NOVEMBER 17, 2025

CONTRACT No. 1827

MISC. HVAC IMPROVEMENTS PROJECT

ADDENDUM No. 02

CONTRACT 40 SHEET M-6

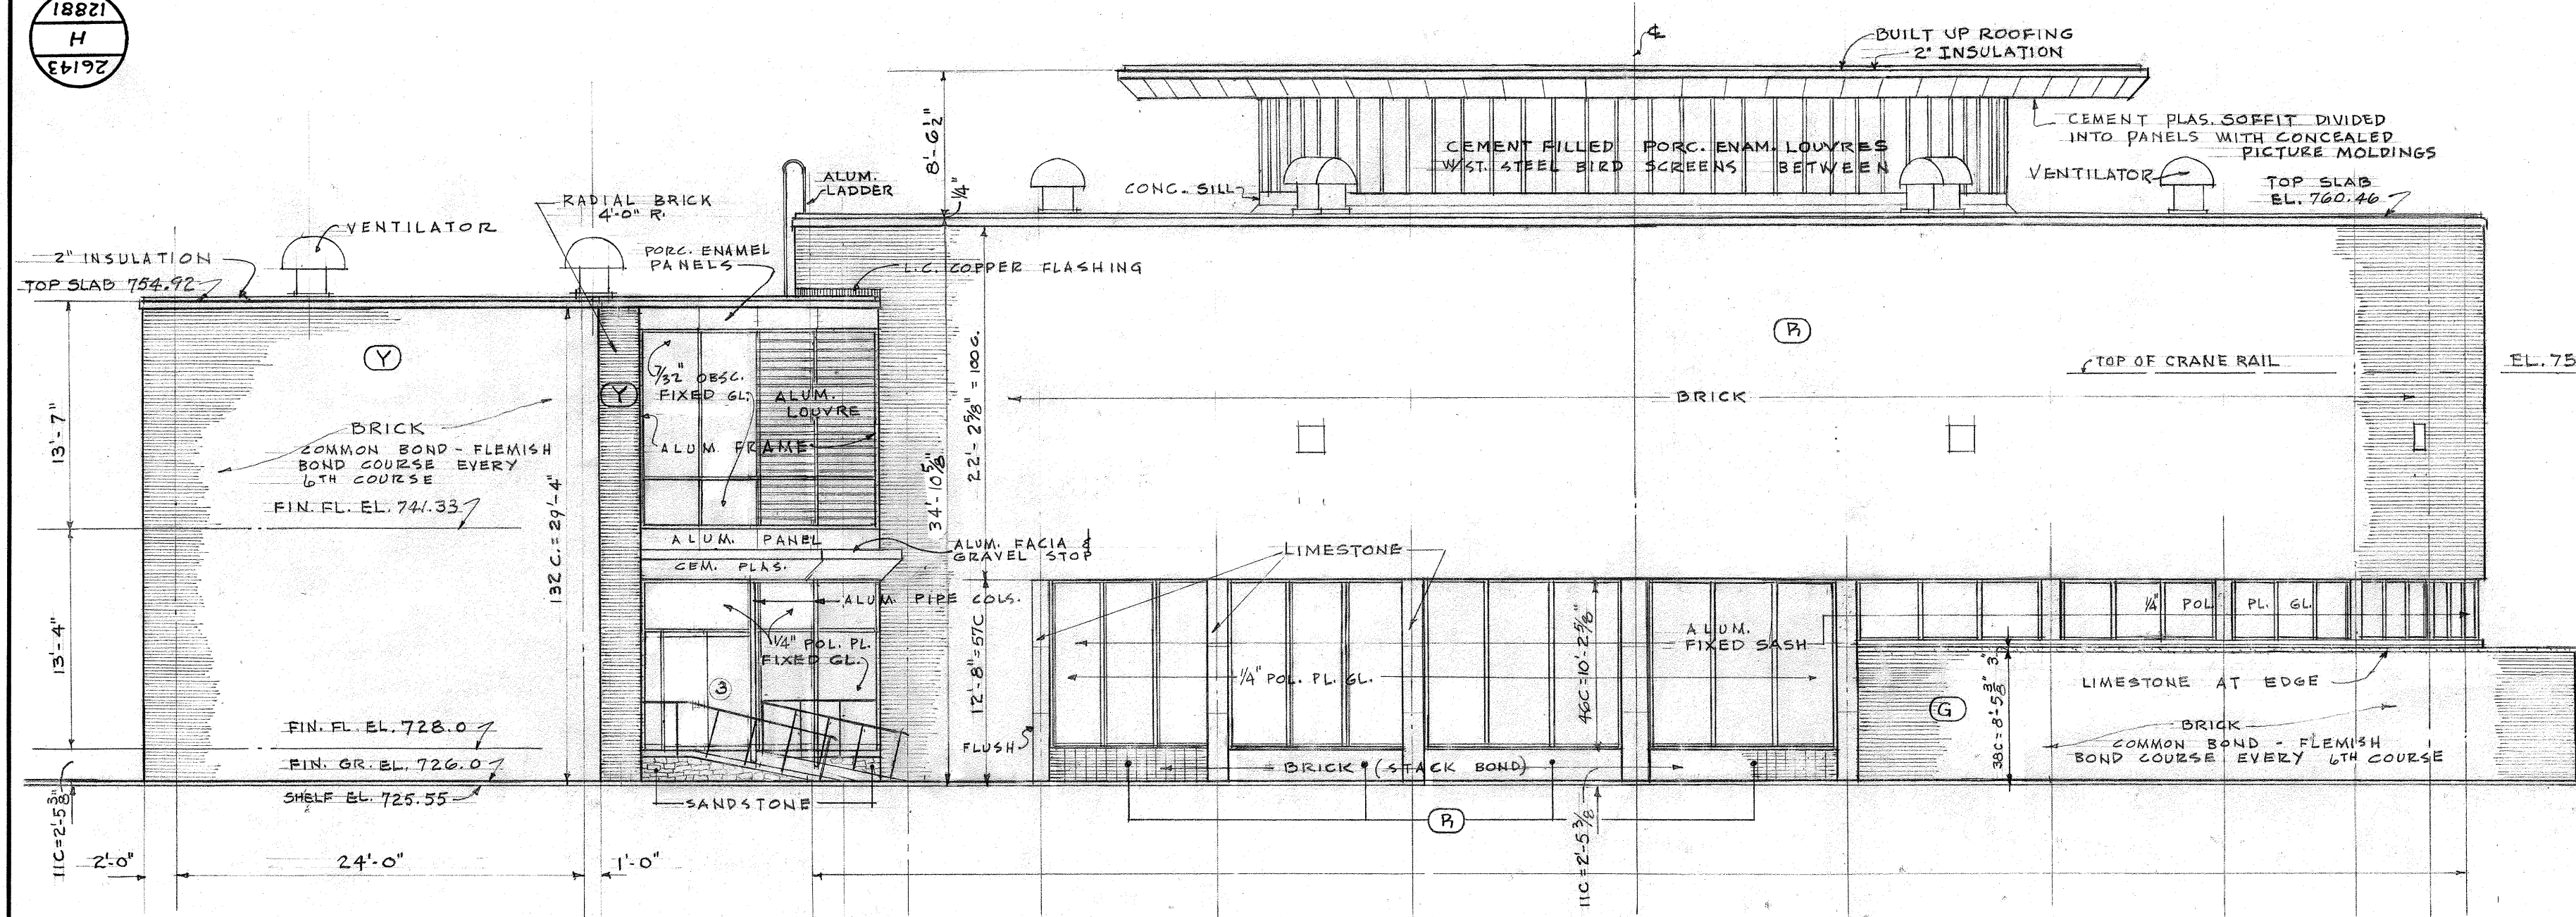
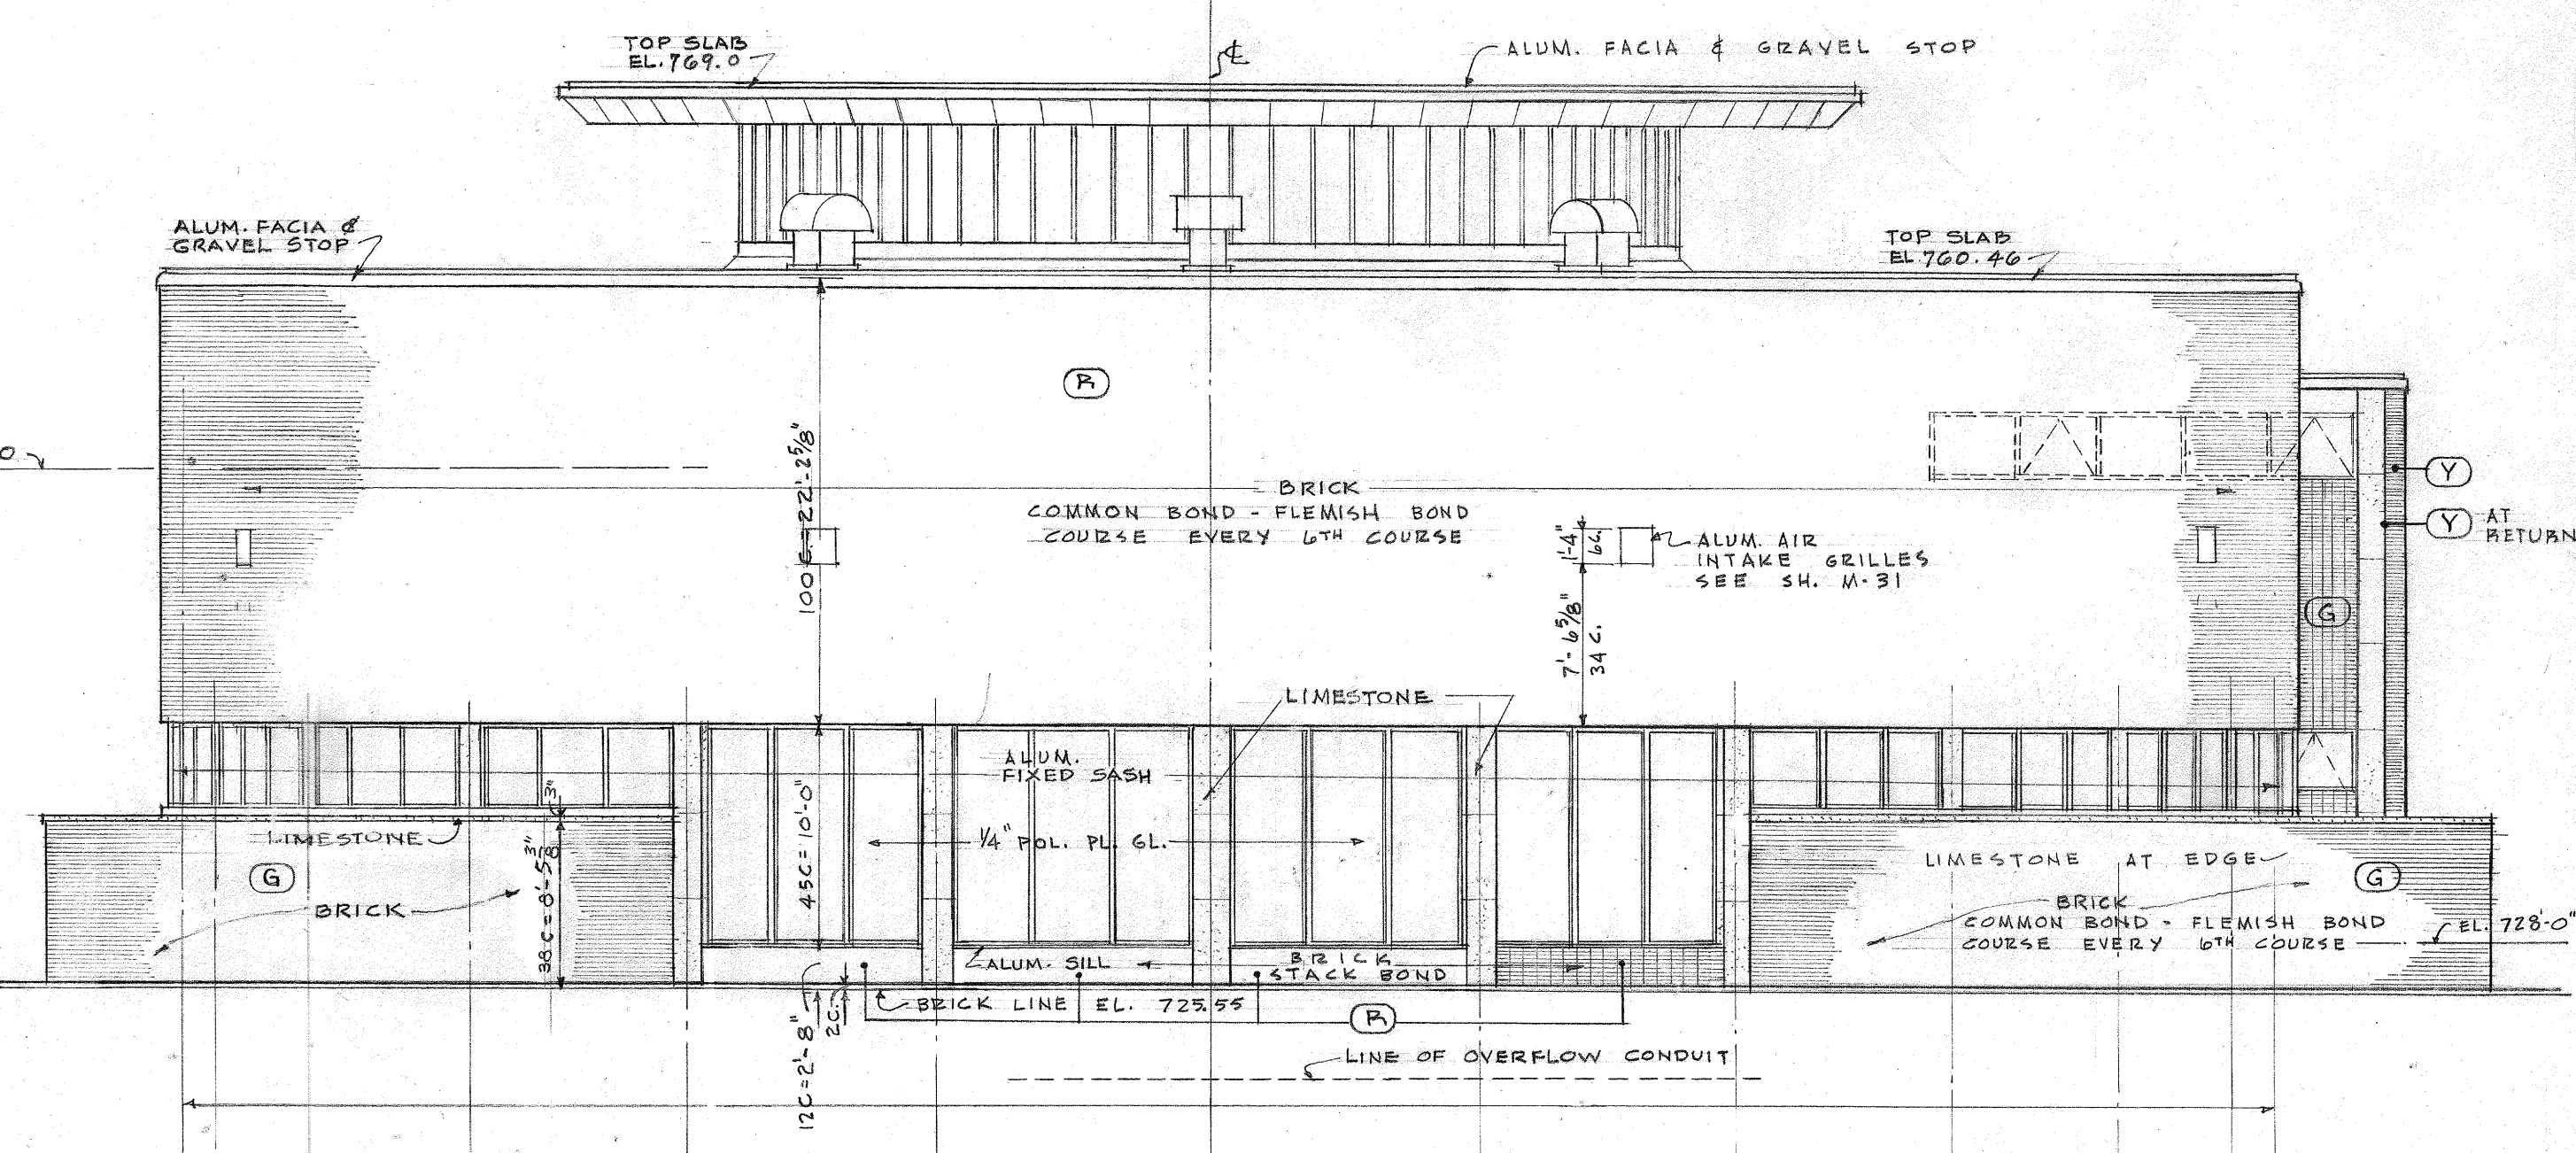
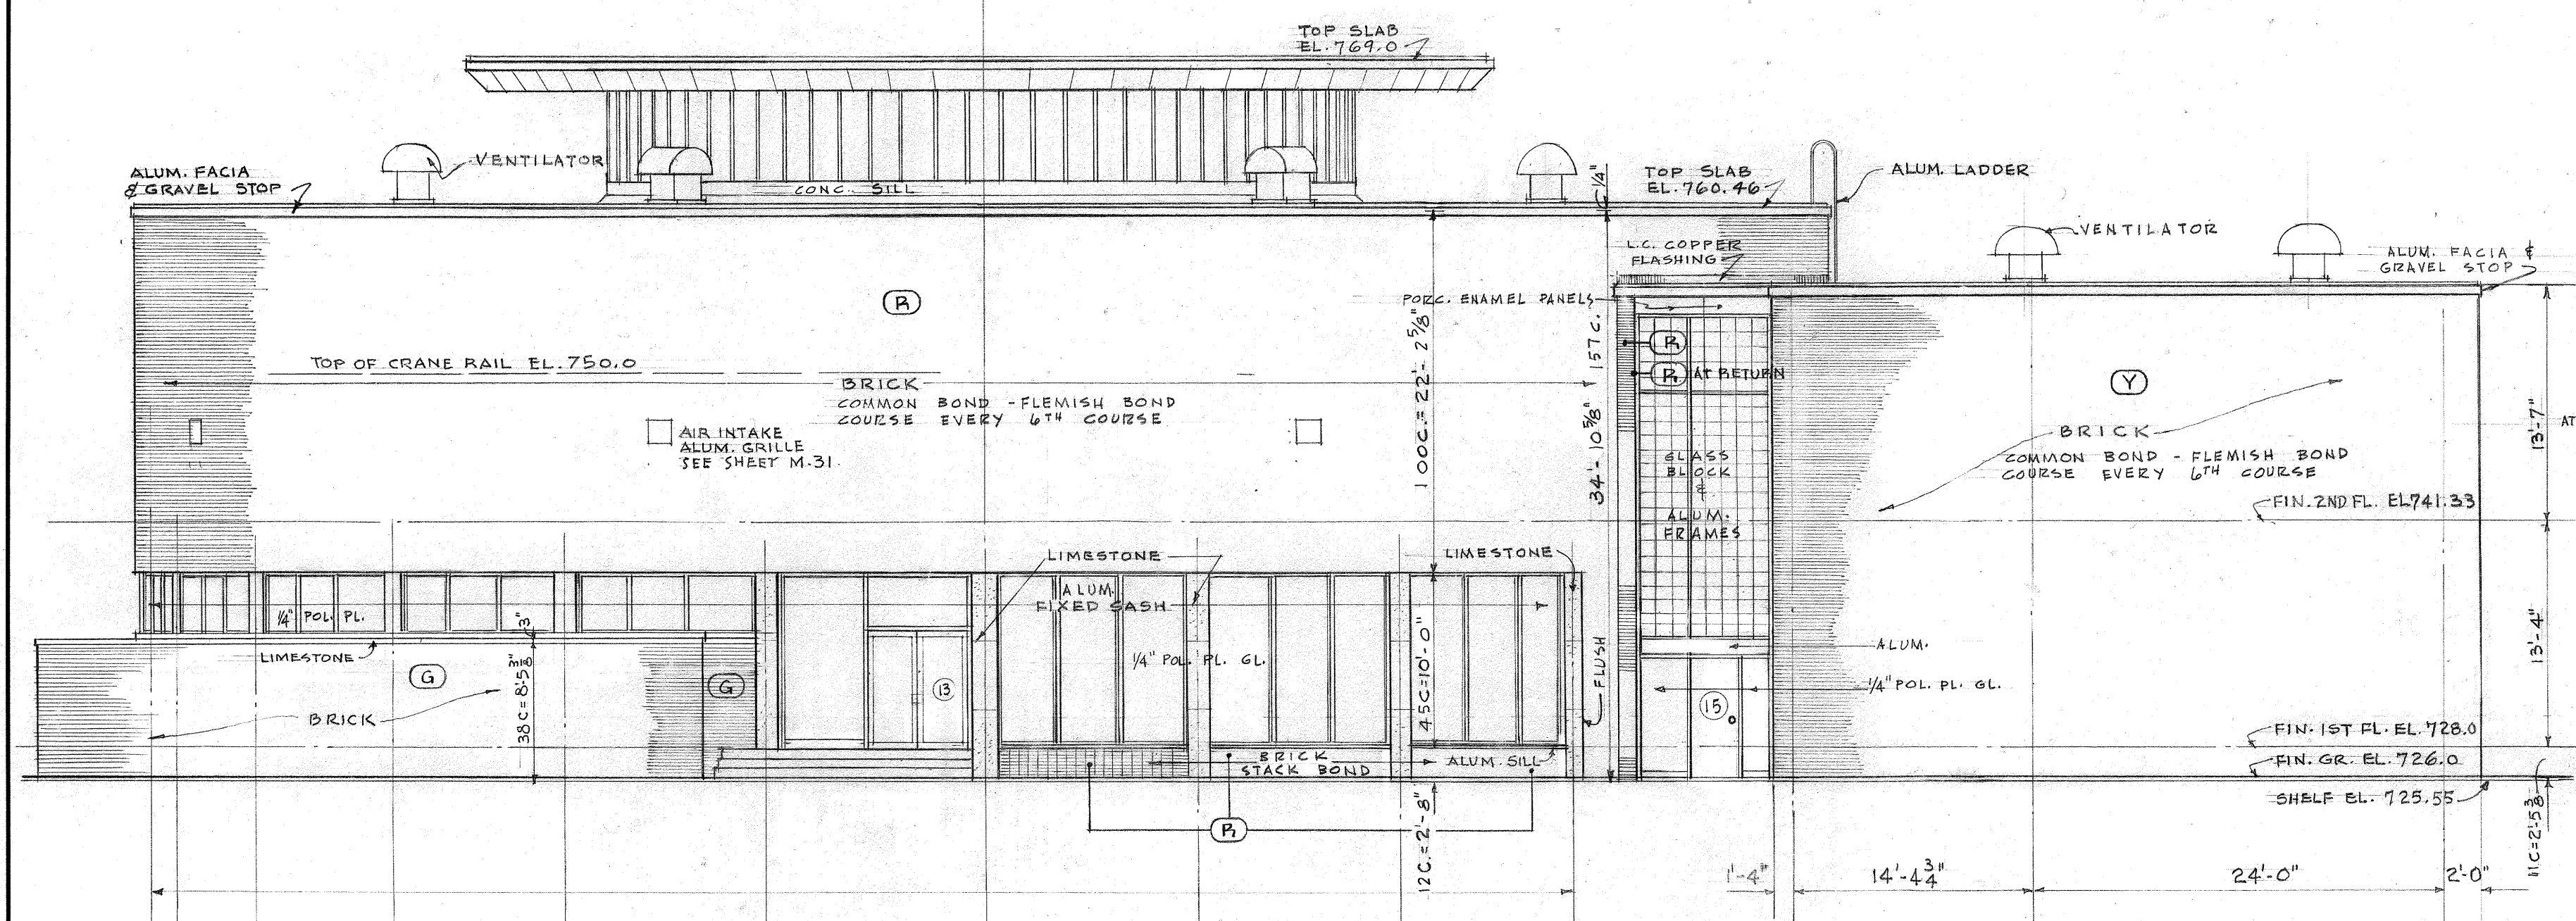
- 3.1 Additional asbestos surveying has been completed at the west headworks (512) and annex buildings (110). No asbestos was found. See attachment A and B.
- 3.2 Add sheet M-6, referencing pump station (500) elevation. See attachment C.

Q2: Can we get elevations for the buildings? Especially building 400 and 500

A2: Building 400 is approximately 60 feet, as shown on 400-A-01. Building 500 is approximately 26' 11" as shown on attached drawing M-6 being added to the reference folder. Building 110 is 2 stories and is approximately 30 feet. From Basement, elevation is 42 feet.
